Serial: NPD-NRC-2010-073
September 15, 2010

**SHEARON HARRIS NUCLEAR POWER PLANT, UNITS 2 AND 3
DOCKET NOS. 52-022 AND 52-023
RESPONSE TO SUPPLEMENTAL REQUEST FOR ADDITIONAL INFORMATION
CONCERNING HYDROLOGY CALCULATIONS IN SUPPORT OF A TRITIUM ANALYSIS**

**Shearon Harris Nuclear Power Plant Units 2 and 3
Response to NRC Supplemental Request for Additional Information Concerning
Hydrology Calculations in Support of a Tritium Analysis for the Combined License
Application, dated August 20, 2010**

Figure 1
Depth Profile of Tritium Concentrations

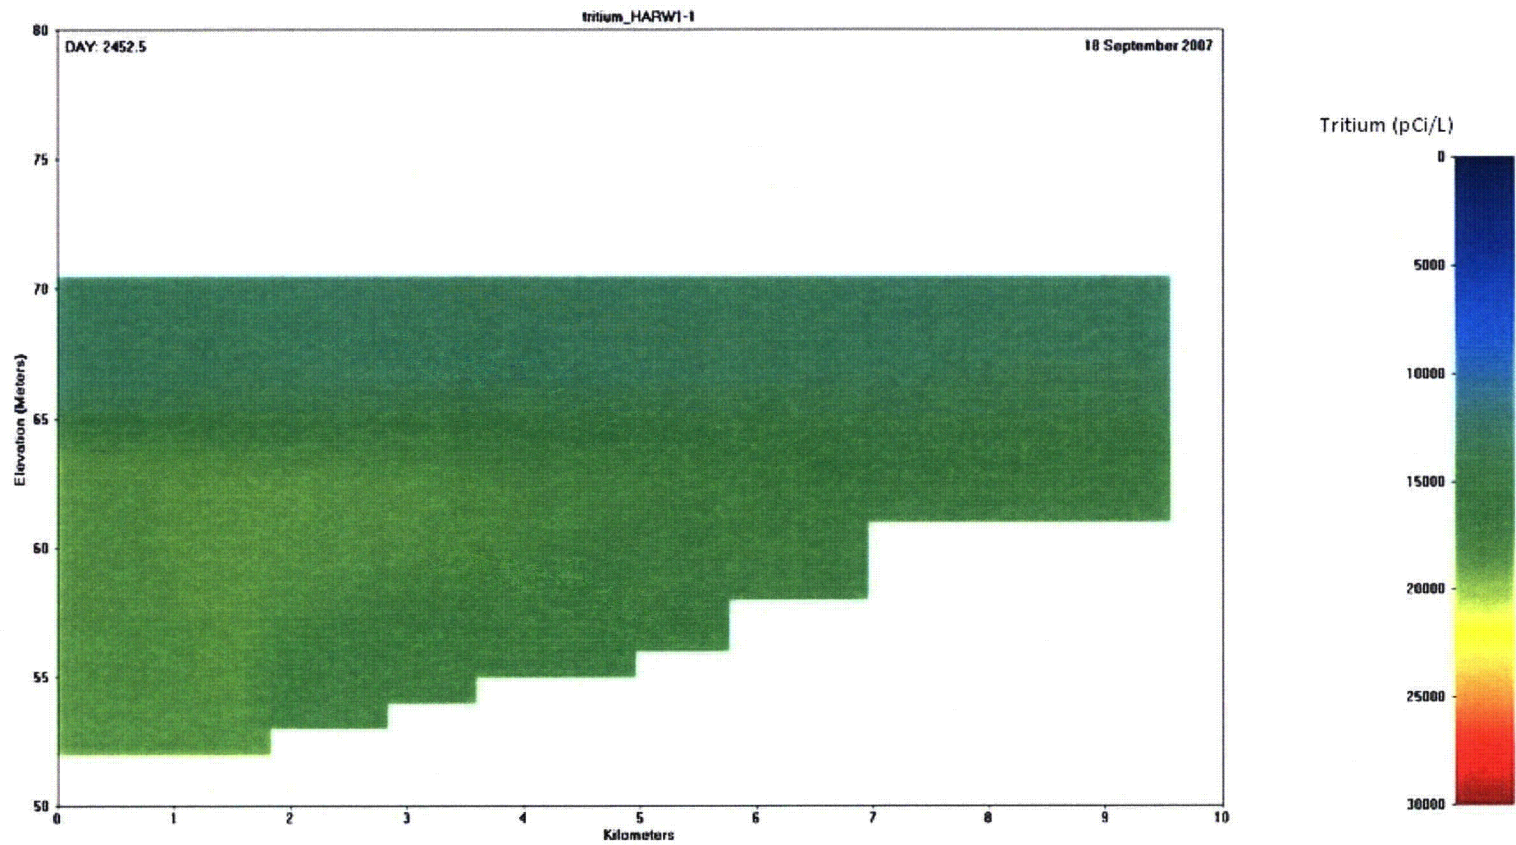
Provide the native files for the model CE-QUAL-W2 for the tritium analysis of Harris Reservoir as discussed in the calculation package HAR-338884- TMEM-122, a table of input parameters and their values which were used for conducting the tritium analysis using the model CE-QUAL-W2, and the model segment and layer numbers from which the results were extracted.

The calculation package HAR-338884-TMEM-122 titled "Modeling of Long Term Tritium Level in Harris Lake," was submitted by Progress Energy. The native files for the tritium model were not provided with the calculation package. Input parameters that govern the transport and fate of tritium were not provided with the calculation package.

The results shown in HAR-338884-TMEM-122 are from the 1-meter surface layer closest to the Main Dam (Segment 13). Review of the evaluations performed in support of the Western Wake WRF study and the tritium modeling results indicated that this segment had the highest concentration of water quality constituents because of flow patterns and stratification of the reservoir in the summer. When the reservoir has stratified, tritium concentrations become fairly uniformly distributed in the volume above and the volume below the thermocline.

Tritium concentrations can build up below the thermocline during the summer resulting in concentrations that are higher than in the surface layer (See Figure 1, *Depth Profile of Tritium Concentrations*), however, the thermocline varies from approximately 5 to 10 meters below the surface. For this reason, the concentrations in the water volume above the thermocline are most relevant to primary contact concerns. Drinking water withdrawals are also above the thermocline and in one of the tributary arms of the reservoir, distant from the main dam. Reservoir turnover occurs each fall, distributing the accumulated tritium load throughout the entire water column.

On average, the tritium concentrations below the thermocline are 20 percent higher than above the thermocline. Review of the model predictions show that concentrations reach their highest level in the elevation range of 180 to 195 feet NGVD29. Table 2 presents the annual average and total average tritium concentrations for the simulation period (2001 to 2008) in the surface layer and at 187 feet NGVD29.
